Alachua County Budget and Fiscal Services Procurement

RE: Addendum #1
Bid 19-900 Poe Springs Road Trail (LAP - FPN 433990-2-58-01)

ALACHUA COUNTY
COUNTY ROAD NO. 340 SHARED USE PATH

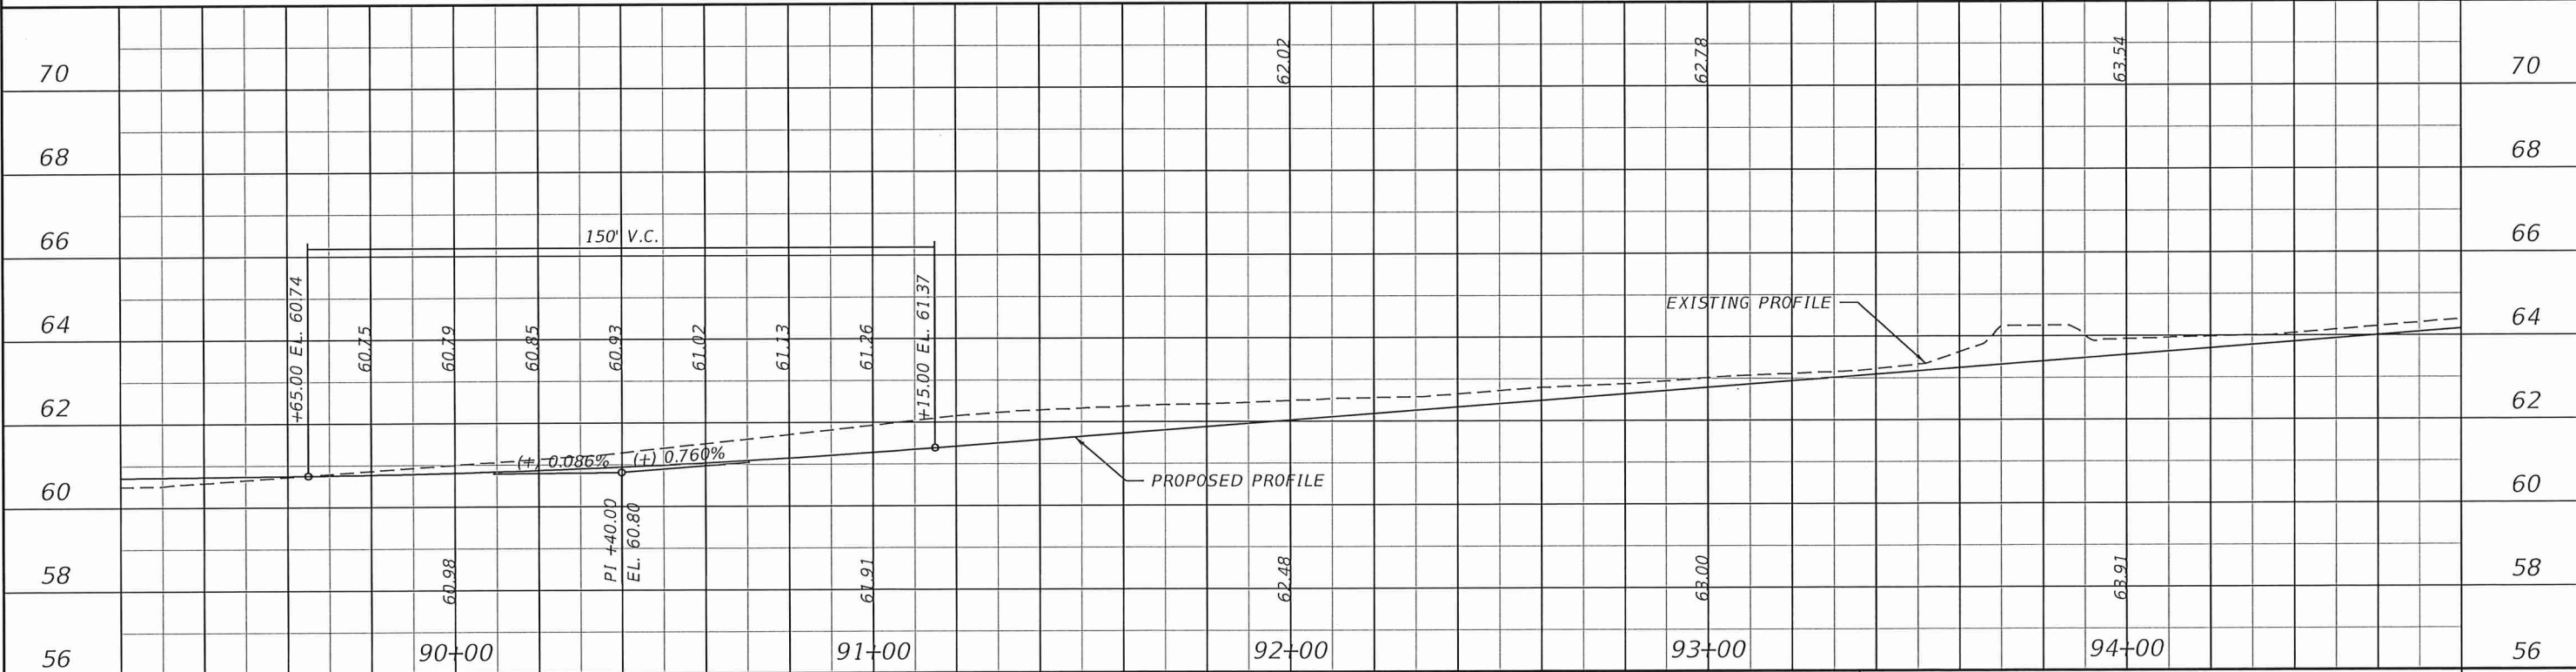
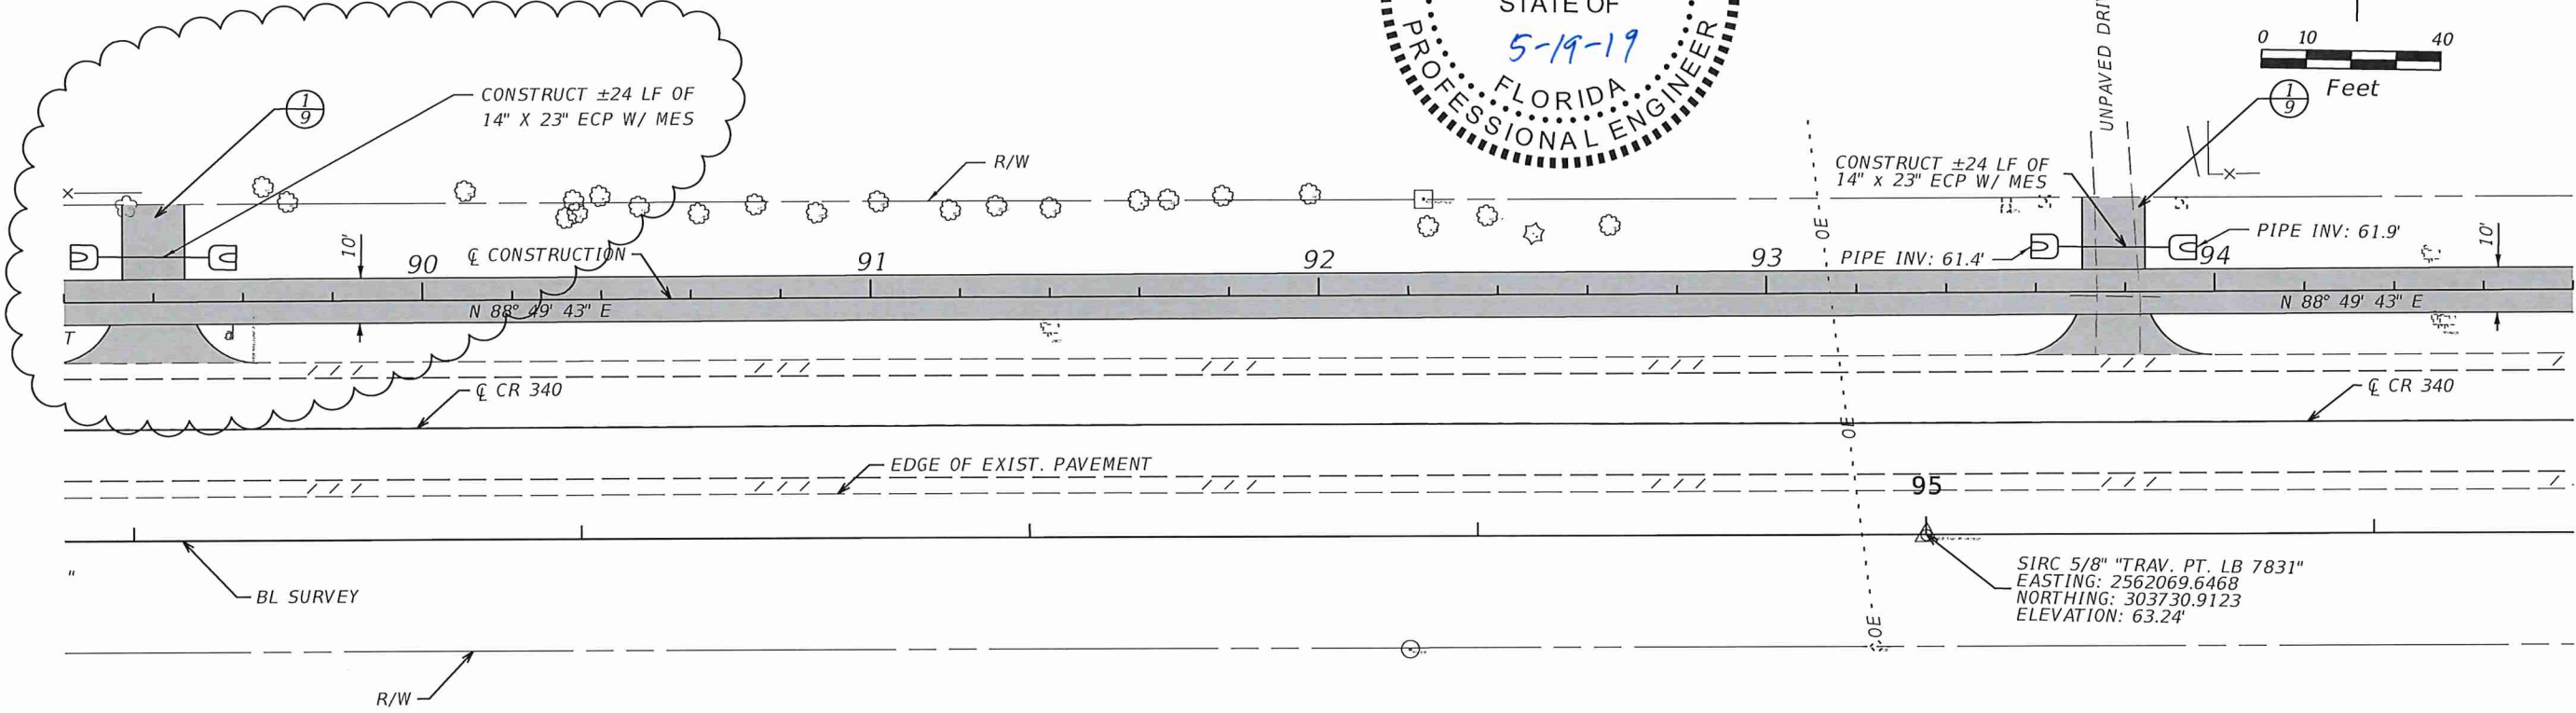
REVISIONS				James H. Pitman Jr., P.E. P.E. LICENSE NUMBER 42035 NORTH FLORIDA PROFESSIONAL SERVICES PO BOX 3823 LAKE CITY FL, 32056 CERTIFICATE OF AUTHORIZATION 29011	ALACHUA COUNTY PUBLIC WORKS			PLAN & PROFILE SHEETS	SHEET NO.
DATE	DESCRIPTION	DATE	DESCRIPTION		ROAD NO.	COUNTY	FINANCIAL PROJECT ID		
5/15/19	Δ DRIVEWAY ADDED STA. 89+40.00				CR 340	ALACHUA	433990-2-58-01		28

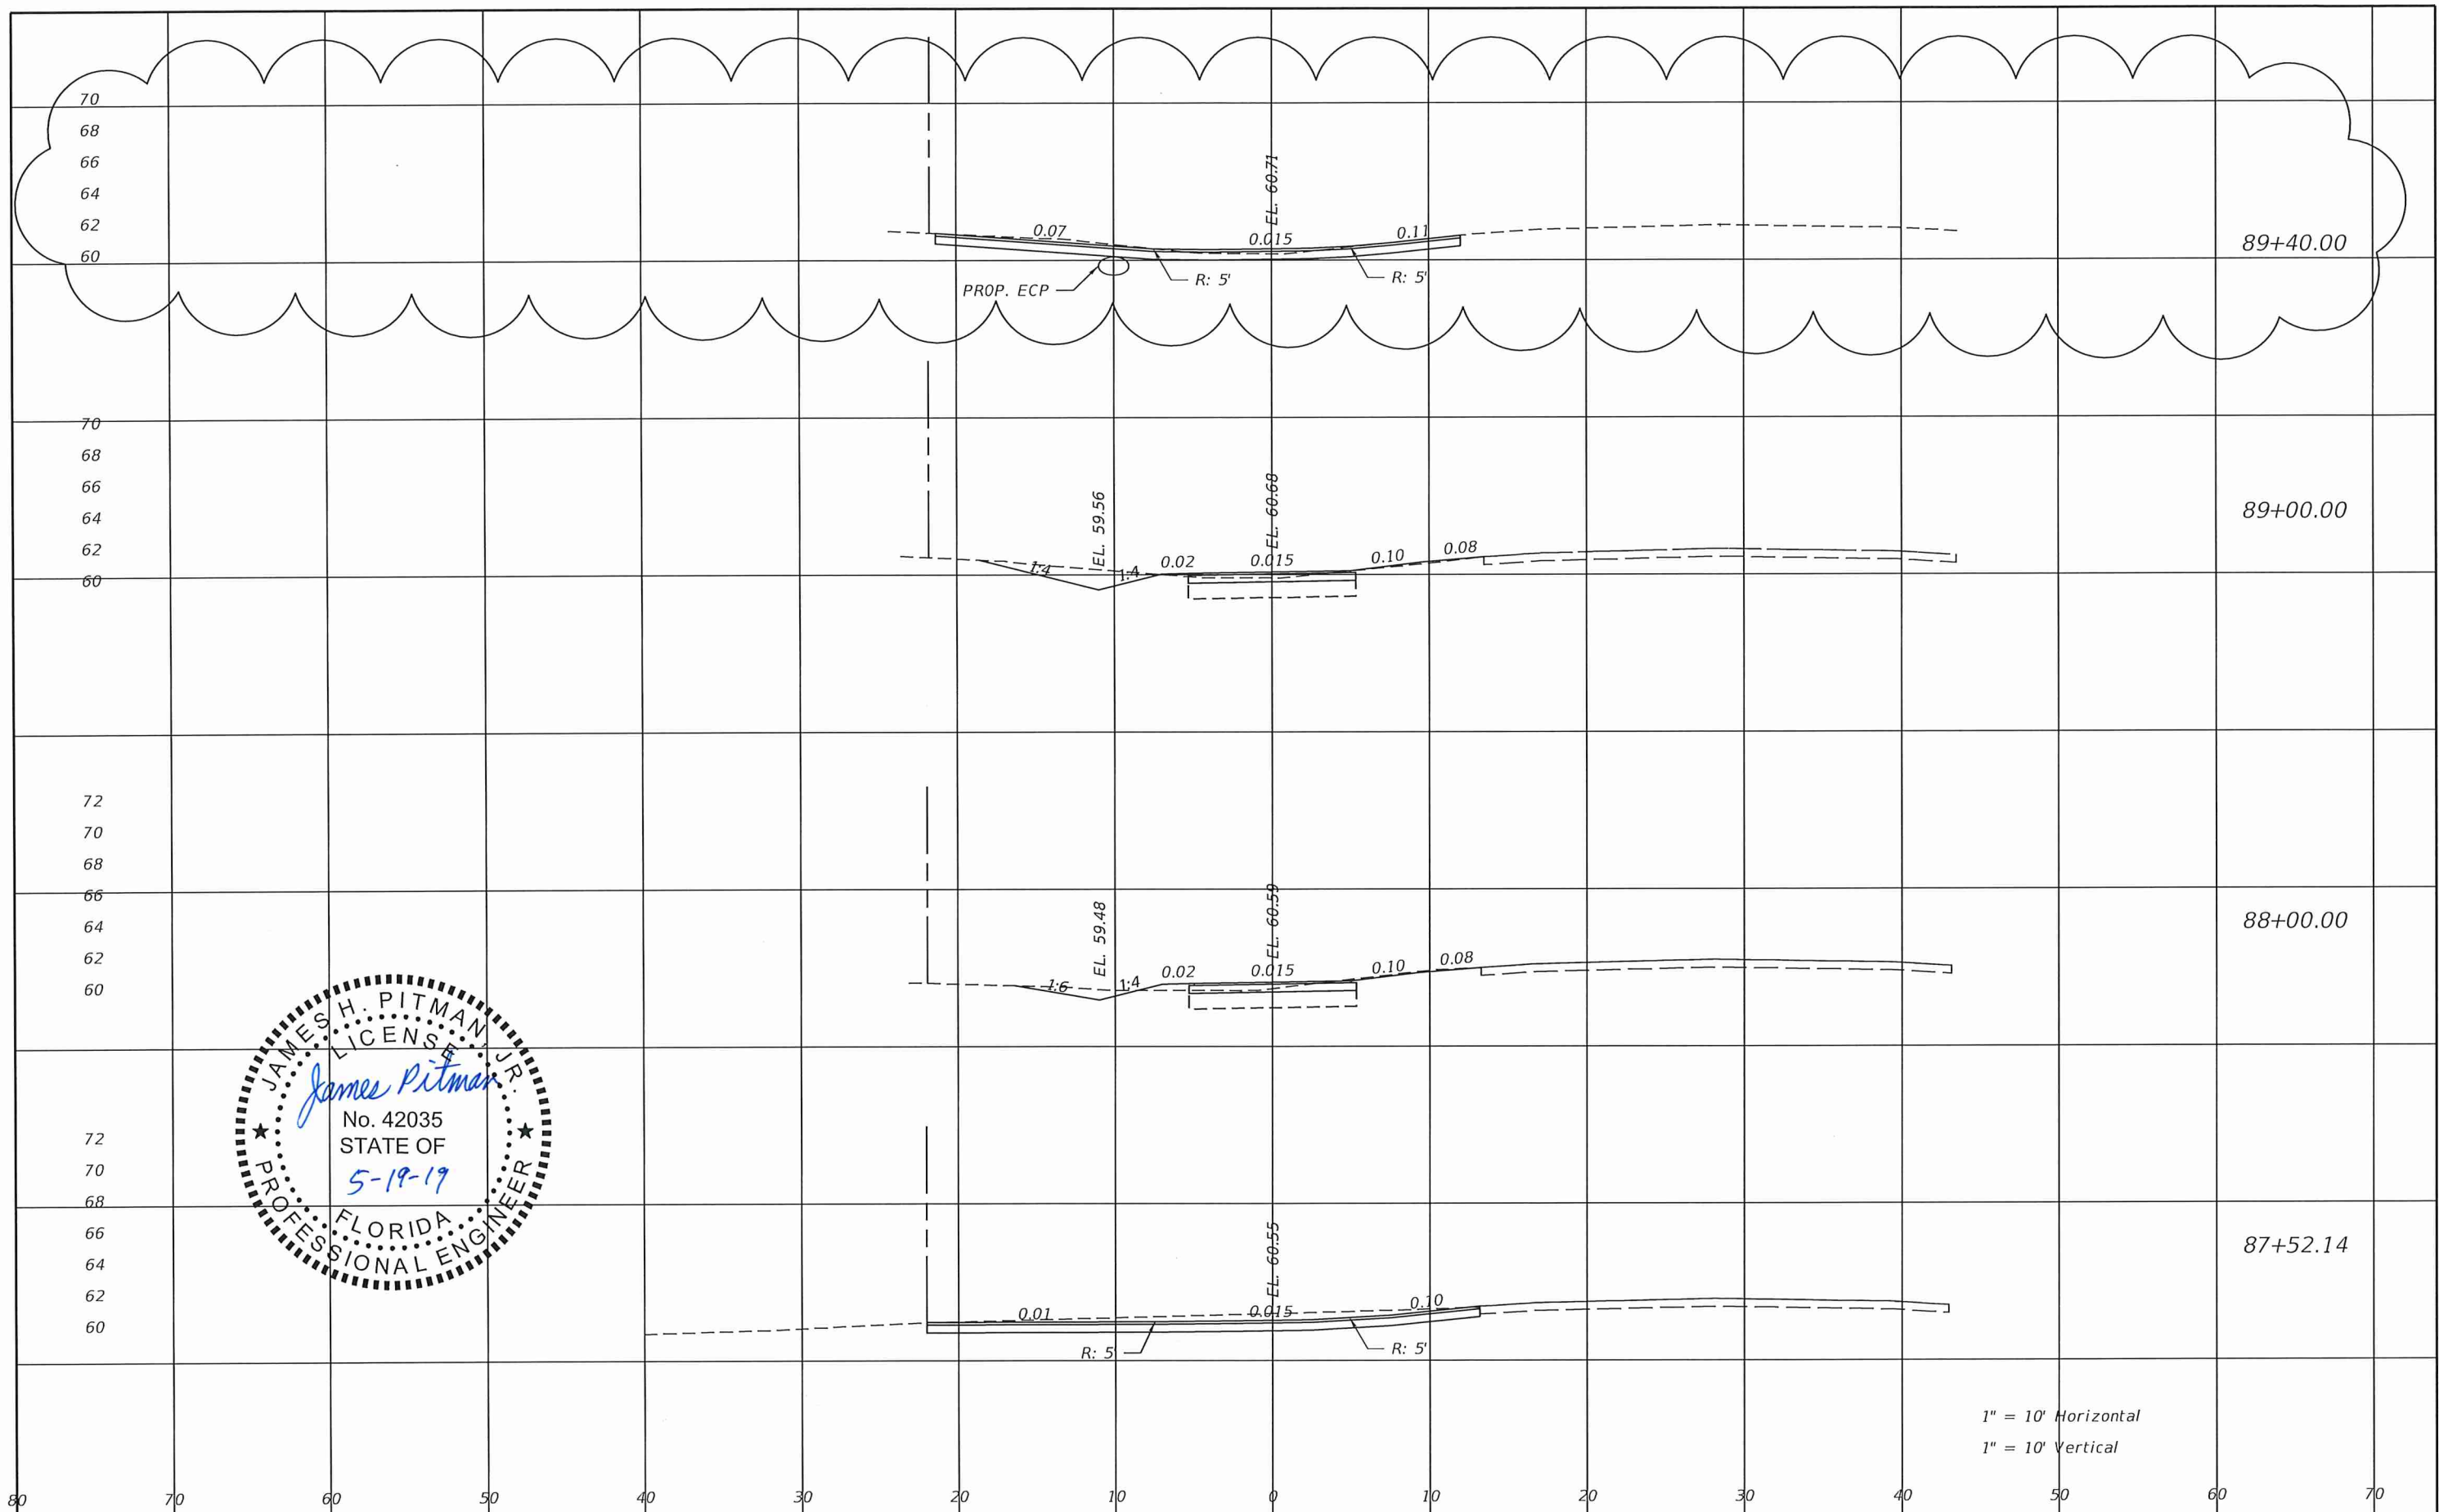
REVISIONS				James H. Pitman, Jr., P.E. P.E. LICENSE NUMBER 42035 NORTH FLORIDA PROFESSIONAL SERVICES PO BOX 3823 LAKE CITY, FL 32056 CERTIFICATE OF AUTHORIZATION 00029011	ALACHUA COUNTY PUBLIC WORKS			CROSS SECTION SHEETS	SHEET NO. 79
DATE	DESCRIPTION	DATE	DESCRIPTION		ROAD NO.	COUNTY	FINANCIAL PROJECT ID		
5/15/19	△ DRIVEWAY ADDED				CR 340	ALACHUA	433990-2-58-01
